Clonskeagh Road (UCD to Clonskeagh Bridge)

Dún Laoghaire-Rathdown published a [Public Consultation report](#) and [Layout Plans](#) for the Clonskeagh Road (UCD to Clonskeagh Bridge) project in July 2020.

Layout sheet 1 (Clonskeagh Bridge)

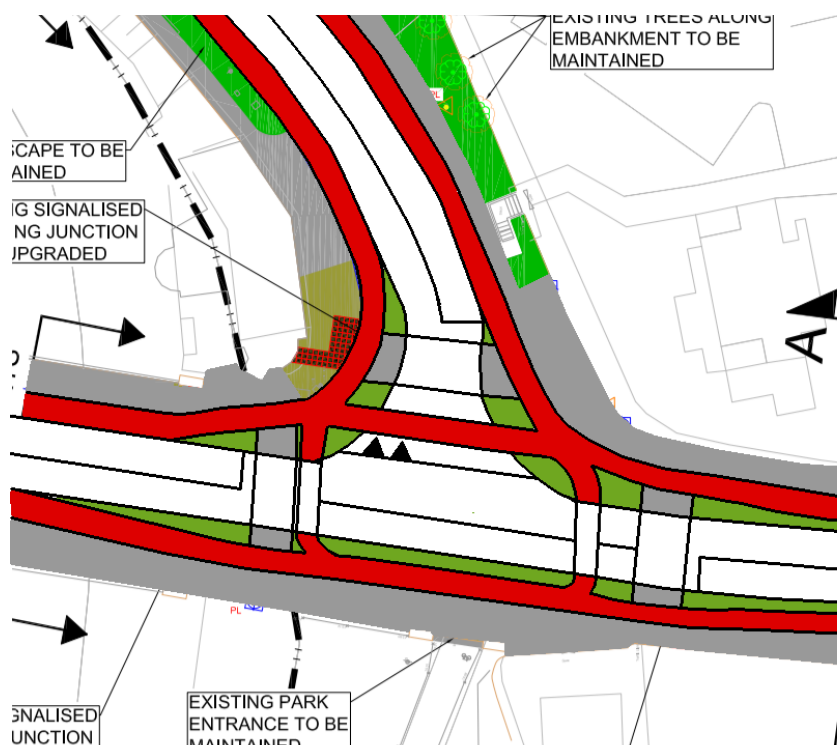
We are extremely disappointed with the design of the Beech Hill Road junction. For people cycling, this junction design offers minor improvements, but it fails to address the reasons that this junction is so hostile and dangerous.

1. Northbound drivers continuing straight routinely invade the existing cycle lane to avoid cars waiting to turn right. This scheme does absolutely nothing to prevent this behaviour. We would like to see a segregated raised cycle track installed here, with a 30-50cm buffer between the traffic lane and the cycle track to keep people safe when cycling.
2. Cyclists wishing to turn right onto Beech Hill Road have to cross a busy traffic lane, avoiding the cars mentioned in the previous point. Some cyclists may be comfortable making this maneuver. However, for a less experienced cyclist, or perhaps a child cycling to David Lloyd, this feature makes the junction

impossible to safely navigate. Once again, this scheme fails to address this problem. We would like to see a dedicated space with its own traffic signal allocated for right-turning cyclists. This right turn cycle lane should also connect to a cycle lane on Beech Hill Road to ensure that cyclists aren't forced to compete with cars for space as they turn onto Beech Hill Road.

3. Currently, the southbound cycle lane on Clonskeagh Road also functions as a left turn lane. We welcome the decision to remove the left turn lane and make the cycle lane mandatory. However, we have observed elsewhere in the city (for example on Richmond Street South) that drivers often use mandatory cycle lanes as left turn lanes. As stated in point 1, the problem is the lack of a physical buffer between the traffic lane and the cycle path. This cycle track needs to be clearly protected

4. On weekday evenings, Beaver Row backs up almost the whole way to the N11. This is extremely hostile to people cycling who are left with almost no space. This lack of space becomes particularly problematic near the Beech Hill/Clonskeagh Road junction, where cyclists are at risk of getting caught in blind spots. This scheme is an opportunity to provide protected cycle paths on Beech Hill Road between the business park entrance and Clonskeagh Road, which will improve safety and reduce the risk of people cycling who regularly get cut off by left-turning drivers.

Ultimately, the only way to provide segregated and sufficiently wide cycle paths without narrowing the footpaths is to remove the right turn lane. The image above

shows how the removal of this lane would create enough space for a much safer junction design which is safe enough for a child to cycle to school.

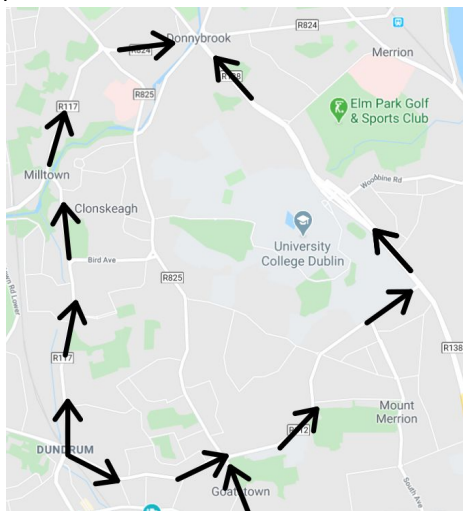
Removing the right turn lane might require a right turn ban. However, most inbound traffic would be able to access the N11 just as easily using Mount Anville Road/Foster's Avenue, or using Milltown Road/Eglinton Road, as shown in the map below. This underlines the need for schemes like this to be part of broader traffic management that prioritises sustainable modes of transport over unsustainable modes.

Reducing the number of cars using Beaver Row would also benefit passengers on the 11 bus. Currently, this bus is constantly stuck in traffic, and it can take 20 minutes to get from Goatstown to the Dodder bridge some mornings. Banning the right turn onto Beech Hill Road would remove a huge volume of inbound traffic on Clonskeagh Road, dramatically improving the reliability of this bus service.
